Public Contract Application for Contractual Changes

Where	opportunity lives Contractual Change		Fax: 918-259-8453 - Office: 918-259-700
Project Name:	County Line Trunk Sewer Ph 2A	Project Number:	2154520
PO Number:	Loan # ORF-23-0167-CW	Date of Application:	Friday, September 26, 2025
Contractor:	Belt Construction, Inc	Submitted By:	Chris Burmeister (PM)
	Summary of Change in S	Scope of Work	
The following scor	be of work consisting of work location, work description, esta	ablished quantities, and timeling	ne for completion has been reviewed

County Line Trunk Sewer Ph 2A
County Line Rd and New Orleans St
Markup of Proposed Solution

PROJECT: County Line Trunk Sewer Ph 2 BAMA PROJECT NUMBER: 2154250 BELT PROJECT NUMBER: 2506 PCO 01

Inside existing utility manhole at Sta 144+11

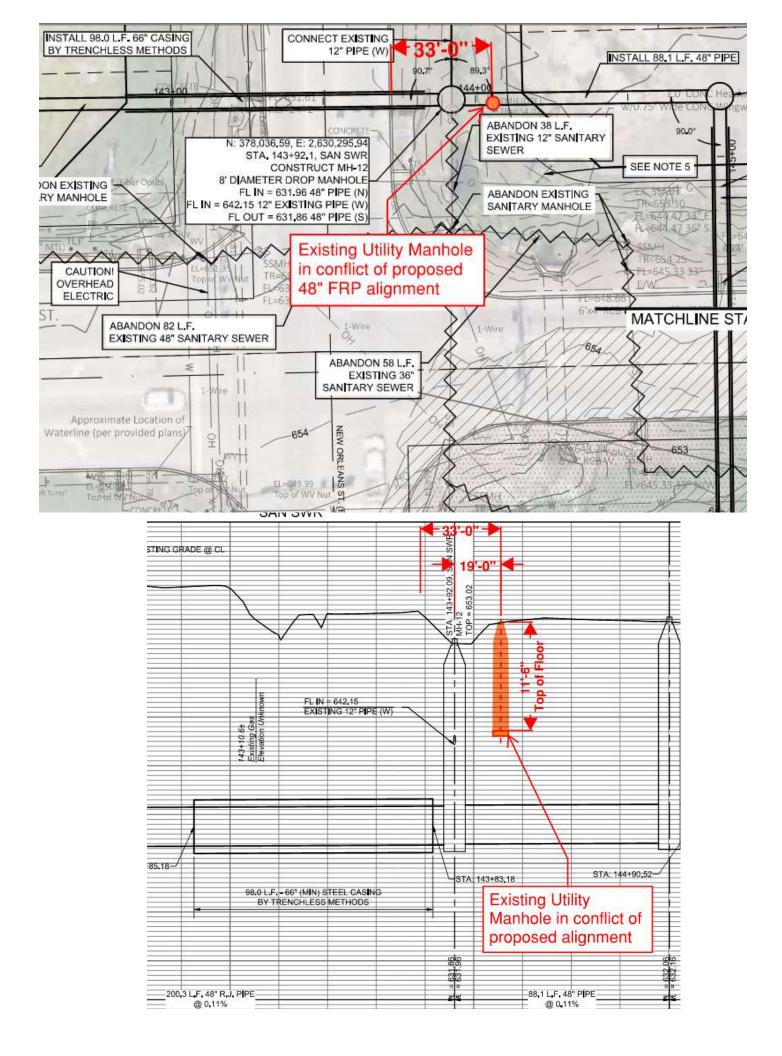
QUESTION:							
There is an existing concrete 4ft dia manhole over the proposed sewer alignment at Sta 144+11. The depth from rim to top of floor measured approx 11.50 Ft. The location of the existing manhole appears to be directly over the proposed 48" FRP sewer line and could also possibly conflict with the bore receiving pit. Please advise.							
Proposed Solution: 1. Extend the 66" casing 8ft past the exist.	sting utility manhole, shift MH-12 to th	e north and re-reroute the 12" sewer line.					
Please Respond by This Date: At your e	arliest convenience						
Submitted by: Chris Burmeister
